Village of Mukwonago
Notice of Meeting and Agenda

PLAN COMMISSION MEETING
Tuesday, October 10, 2023

FINAL DEVELOPMENT PLAN REVIEW AS A PLANNED UNIT DEVELOPMENT

Proposal:	PUD – 4 Single Family Lots
Applicant:	Warren Hansen (Applicant)
Request:	Final Development Plan - PUD
Staff Recommendation:	Deny

1. Site Plan
2. SWMP

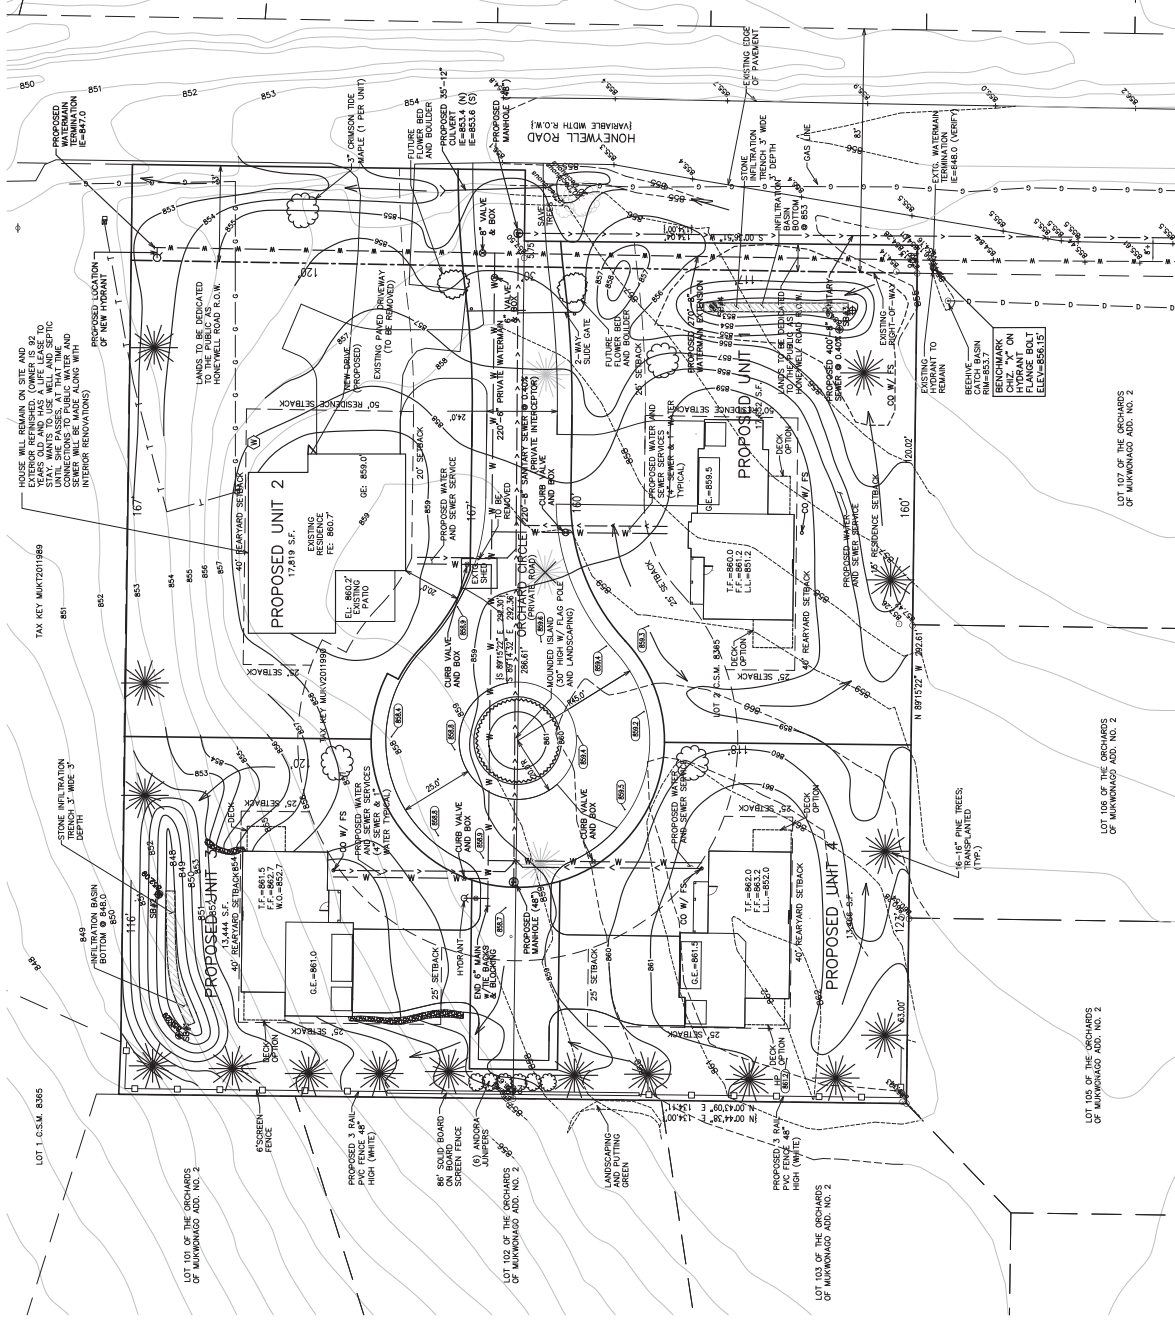
Additionally, the infiltration basins are very close to Units 1 and 3 and don’t appear to meet the requirement of a 50-ft setback for Ordinance Section § 34-110(d)(6)i.2, which requires a 50-ft setback for any structure containing a basement, from a basin that permanently or temporarily holds water during the 100-year storm event. 50-ft set-back is measured from the elevation of the 100-year peak water level if that water level is 1-ft or deeper (which it appears to be in both). The scanned PDF plan is not scalable for me, so I can’t verify to 100% certainty, but I am basing it off scales of other dimensions that are shown on the plans.

Based on the above, I will hold off on performing a more in-depth review and recommend that this project **not** be approved at this time. There may be a need for site layout modifications to meet the ordinance requirements and I’d hate to see Plan Commission approve a site and then have the site get completely modified and have to go back to plan commission to re-review.”

1. Need to move/extend a couple things per notes I made on the plans.
2. Existing house will need to connect per Village ordinance, see plans.
3. Water and sewer within PUD shall be private per current plans.
4. Developer will need to follow Village Construction Specs for all Utilities public or private. We will also require utility as-builts.

Staff recommends the Plan Commission recommend the Village Board deny the application for the proposed 4-Lot PUD and the applicant is to resubmit a plan based on the above staff comments.
